**CONESTOGA-ROVERS
& ASSOCIATES**

December 15, 2014

Reference No.090476

Subject: Comments on the January 15, 2014 Feasibility Study
For the Confederate Park Site prepared by Geosyntec
Jacksonville, Florida
CRA Project Number 090476

Model of USA using $K=1.22$ m/d and $Q = 8.5$ gpm

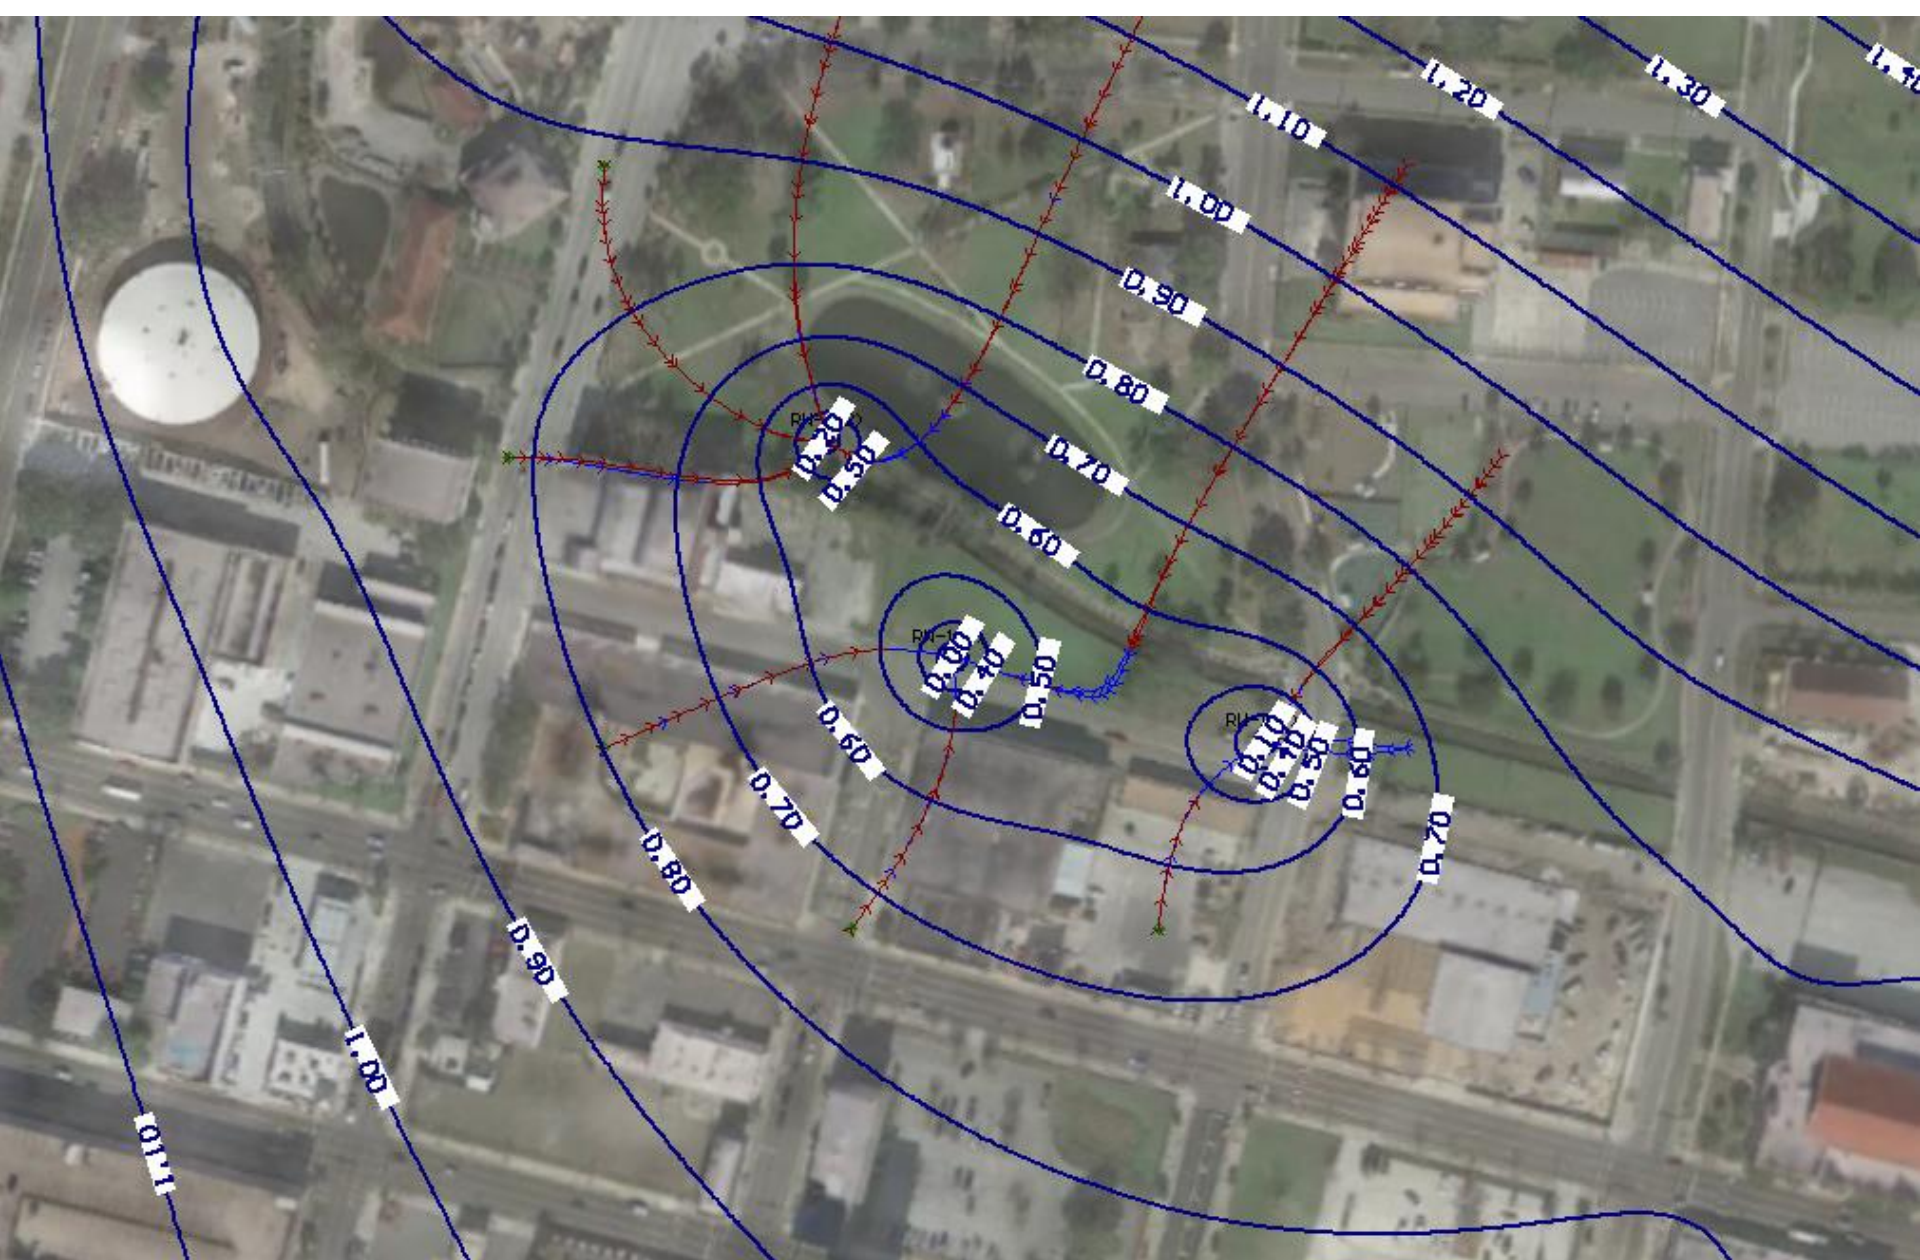
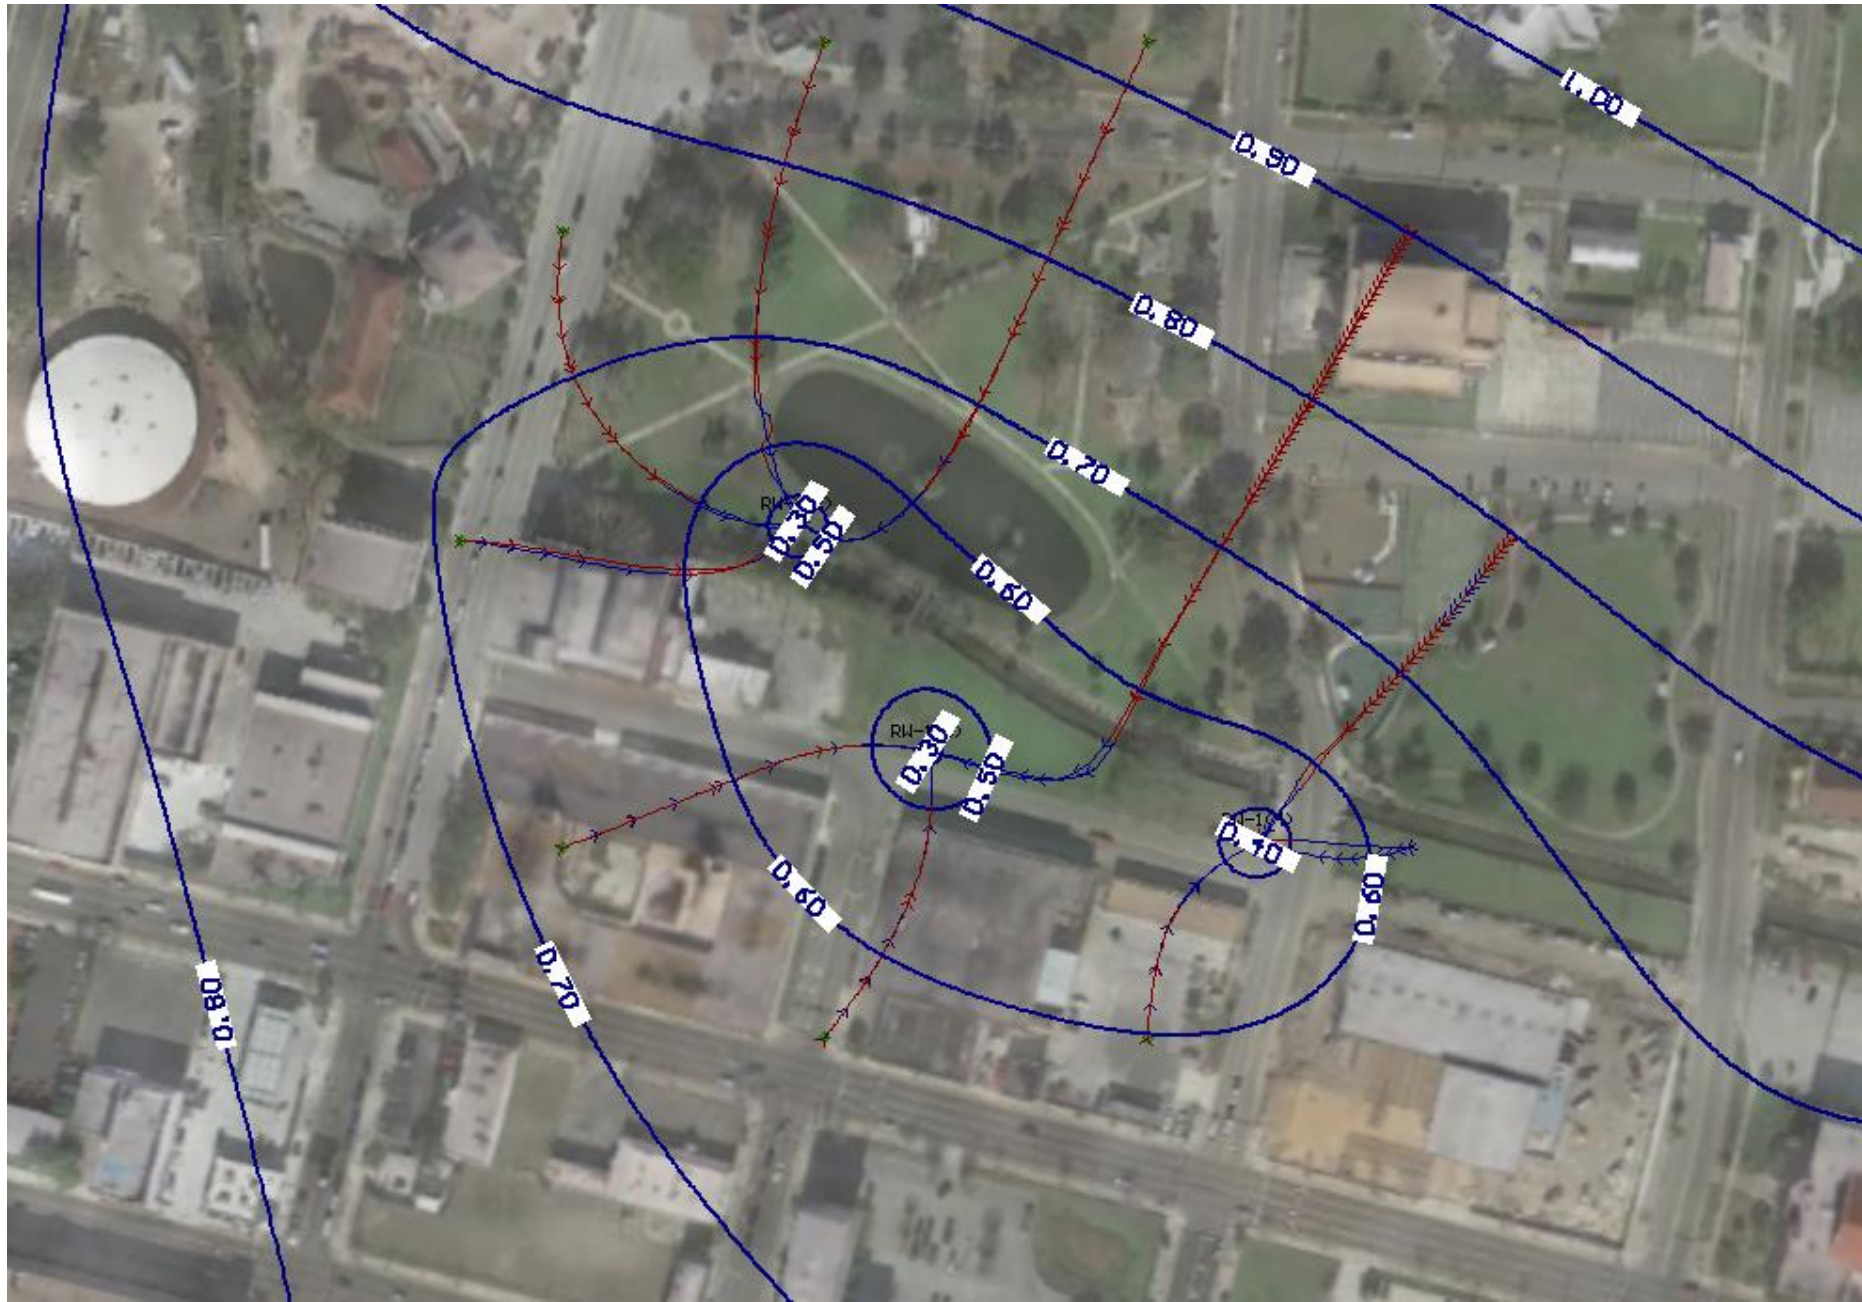
Instead of pumping from the decorative pond to maintain hydraulic control as proposed in the FS, the pond will be lined and three groundwater recovery wells will be used to capture the plume. CRA conducted feasibility-level modeling with sensitivity analyses by varying the hydraulic conductivity and pumping rate. The three-dimensional numerical model constructed with Visual MODFLOW that was used for the report entitled *Confederate Park Hydraulic Control Design Evaluation* dated November 2013 was used to simulate various groundwater recovery scenarios to assess hydraulic control of the dissolved plume. Modifications to the model included modeling the sides and bottom of the decorative pond with a liner (AquaBlok) using a hydraulic conductivity of 1E-9 centimeters per second (cm/s). The sides and bottom of approximately 375 meters of Hogan's Creek were also similarly modeled. The sides of the pond and Hogan's Creek were both simulated with the "wall" feature. The bottom of the pond and the creek were simulated by adjusting the vertical hydraulic conductivities associated with the MODFLOW "Lake" and "River" packages.

The recovery wells extend vertically to the deep zone through multiple layers of varying hydraulic conductivity. The recovery wells from the three-well model were all located southeast of the pond and north of Orange Street (**Appendix G**). The scenario was modeled using total pumping rate of 8.5 gallons per minute (gpm). The hydraulic conductivity of the unconfined aquifer (4.0 ft/day), which was determined by Geosyntec using tidal response data, was used for the model simulations. Importantly,

In order to determine the sensitivity of the model to changes in hydraulic conductivity, a range of hydraulic conductivities were modeled including 2.0, 10, and 19 ft/day. The hydraulic conductivity values were derived from the Site and nearby sites based on slug testing (i.e., PVI, geometric average from EHT, 7-11 Store (south of PVI), geometric average from Clara & Simon (south of Warren Partnership), and Horne Earl (northwest of Confederate Park), respectively). While these values are on the order of those derived using areal onsite data, they were derived from slug tests, which are not as reliable as the testing done on-site through the tidal analysis. The hydraulic conductivity was reported as 0.000581 ft/day using slug test at EHT site; however, after examining the raw data of the slug tests, CRA found that the units were reported incorrectly and the correction for the porosity of the filter pack was not conducted. After corrections, CRA estimated the geometric average of hydraulic conductivity as 3.1 ft/day at EHT. CRA also examined the underlying data from the slug tests at Clara & Simon site, and, in fact, two of the three slug tests used to calculate the 19 ft/d value were in error (including data associated with the sand pack instead of the formation itself – a common mistake). The corrected values yielded a hydraulic conductivity of approximately 5 ft/day. Hence, the data from across the area yield a tight dataset centering on 4 ft/day, which was the value used in CRA's modeling effort. Nevertheless, for sensitivity testing, the upper range, uncorrected values will be used as representing the bounds for the worst-case scenario.

Similar to the modeling results based on recovery of water from the decorative pond, the modeling results (hydraulic conductivity equals 4.0 ft/day) indicate that a flow rate of 8.5 gpm flow can effectively capture the groundwater plume. In fact, more groundwater is captured at this pumping rate than is required to encompass the entire plume, meaning that a reduction in this pumping rate may be possible during full-scale design by further optimizing the recovery well locations. The sensitivity analysis used a series of hydraulic conductivity values that indicated capture is feasible at 8.5 gpm. That is, if hydraulic conductivities range from 2 to 19 ft/day, a pumping rate of 8.5 gpm will still create sufficient drawdown to result in adequate plume capture, despite the increase in hydraulic conductivity. Because the goal of the hydraulic control is capture, this pumping rate is sufficient. The results of the CRA modeling are provided in **Appendix G**.

- The best estimate of hydraulic conductivity is 4.0 ft/d based on the tidal response data. At this rate, 8.5 gpm will capture the plume using three recovery wells. This pumping rate may be reduced by optimization during full-scale design.
- A sensitivity analysis using a series of hydraulic conductivity values ranging from 2.0 ft/day to 19 ft/day (i.e., the uncorrected values from nearby locations using slug tests) indicates that 8.5 gpm will capture the groundwater plume.
